工程指示 / 要求簡箋(E.I.)

工程指示編號：EI / 4307 / 22

工程名稱：啟德 6552

工程項目：預製窗 - 大貨鋁窗鋁料加工圖(EI/4162 續)

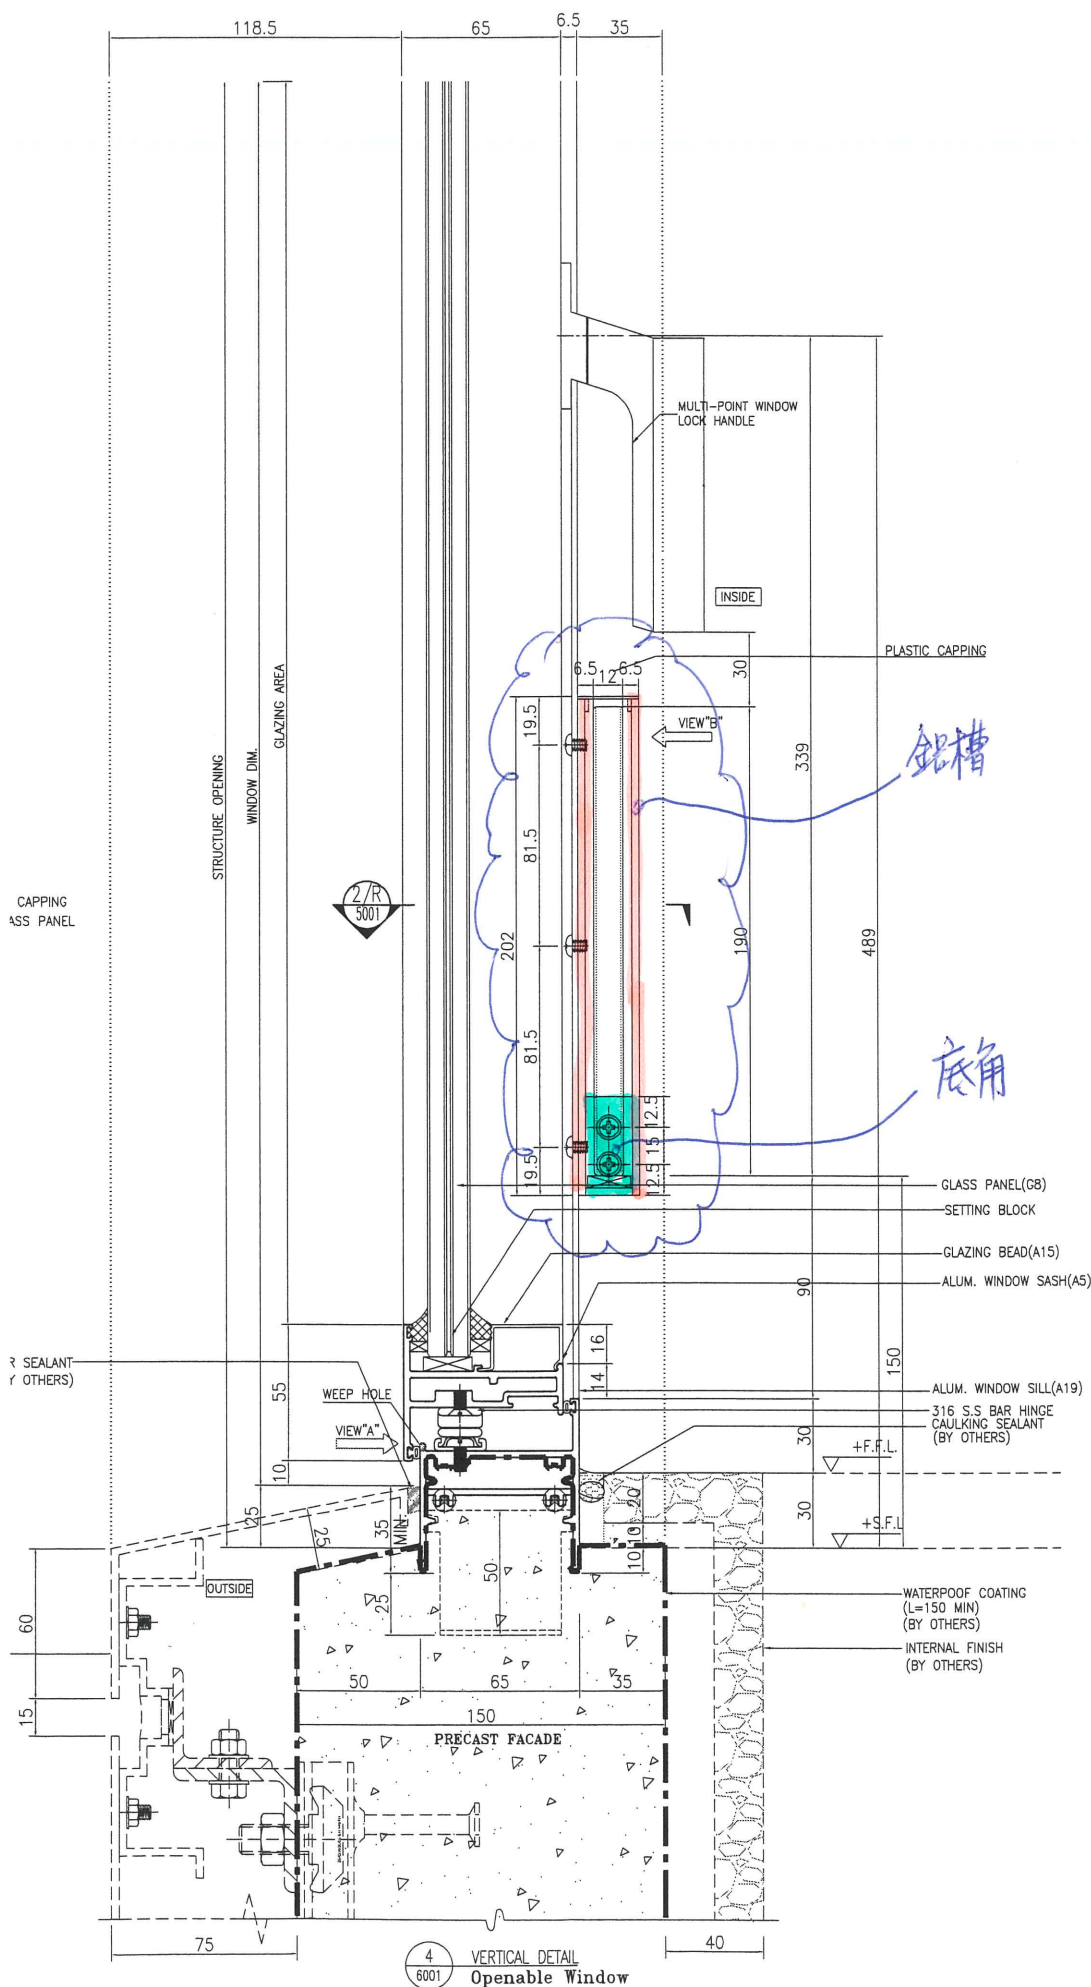
第二批(M02)的玻璃護欄的鋁槽(用 JM3003 切)需要安裝, 底角不需安裝. 見附件.

(待 EI/3940E 訂好新鋁槽後, 底角在地盤安裝, 新鋁槽在地盤更換)

以上第二批(M02)更改包括 T1 座~T6 座的 6/F~8/F 及 T7、T8 座的 8/F~10/F.
